UNITED STATES  
DEPARTMENT OF THE INTERIOR  
BUREAU OF LAND MANAGEMENTFORM APPROVED  
OMB NO. 1004-0137  
Expires: January 31, 2018**SUNDRY NOTICES AND REPORTS ON WELLS**  
*Do not use this form for proposals to drill or to re-enter an abandoned well. Use form 3160-3 (APD) for such proposals.*5. Lease Serial No.  
NMLC067348

8. Well Name and No.  
DIXON YATES LM FEDERAL 0019. API Well No.  
30-015-2327210. Field and Pool or Exploratory Area  
LOCO HILLS; WOLFCAMP11. County or Parish, State  
EDDY COUNTY, NM**SUBMIT IN TRIPLICATE - Other instructions on page 2**

EOG Y Resources requests permission to plug this well using the attached procedure. The current and proposed wellbore schematics are attached.

P&A Procedure  
AFE # 108343

#### Proposed:

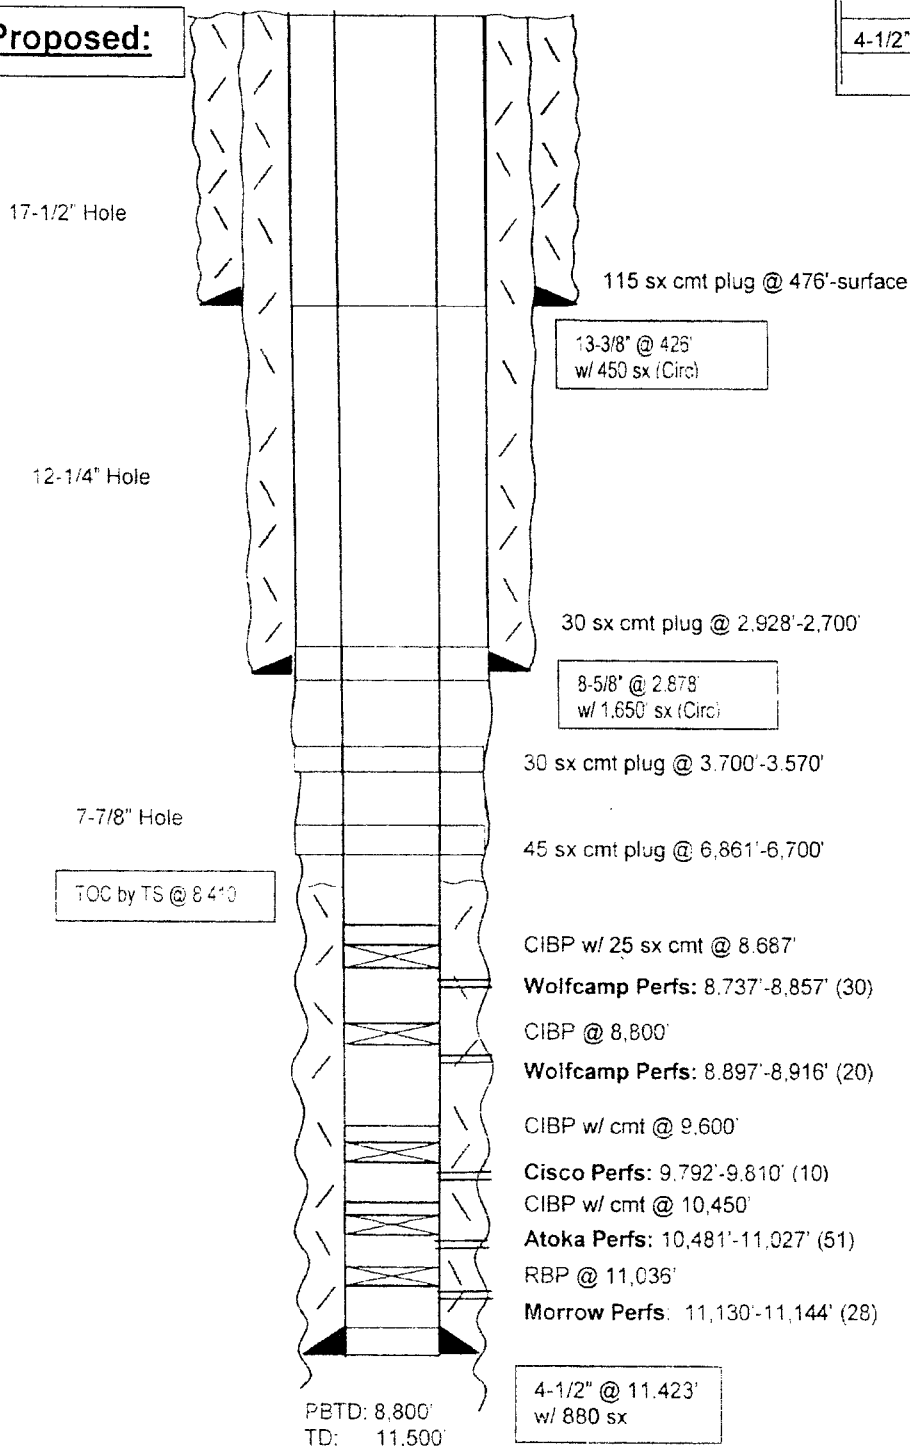
3. RU WL to RIH and perf 4 1/2" casing at 8,861'. POOH. TIH with 4 1/2" packer, set packer at 6,700' and *SQZ spot a 160' (≈ 45 sx) class "H" cement plug from 6,861'-6,700' inside and outside 4 1/2" casing (this will cover top of Bone Springs). Release packer, pick up, reverse tubing clean and POOH. WOC Tag*

4. RU WL to RIH and perf 4 1/2" casing at 3,700'. POOH. TIH with 4 1/2" packer, set packer at 3,570' and *SQZ spot a 130' (≈ 30 sx) class "C" cement plug from 3,700'-3,570' inside and outside 4 1/2" casing (this fulfills minimum plug spacing requirement). Release packer, pick up, reverse tubing clean and POOH. WOC Tag.*

5. RU WL to RIH and perf 4 1/2" casing at 2,928'. POOH. TIH with 4 1/2" packer, set packer at 2,700' and *SQZ spot a 228' (≈ 55 sx) class "C" cement plug from 2,978'-2,700' inside and outside 4 1/2" casing (this will cover 8 5/8" csg shoe and top of San Andres). Release packer, pick up, reverse tubing clean and POOH to WOC. Add Plug Perf @ 1034, SQZ cmt to 934. WOC Tag. (T/Yates)*

6. RU WL to RIH and tag TOC, then pull up and perf 4 1/2" csg at 476'. POOH. Circulate a 115 sx class "C" cement plug from 476' to surface. *SQZ cmt to Surf.*
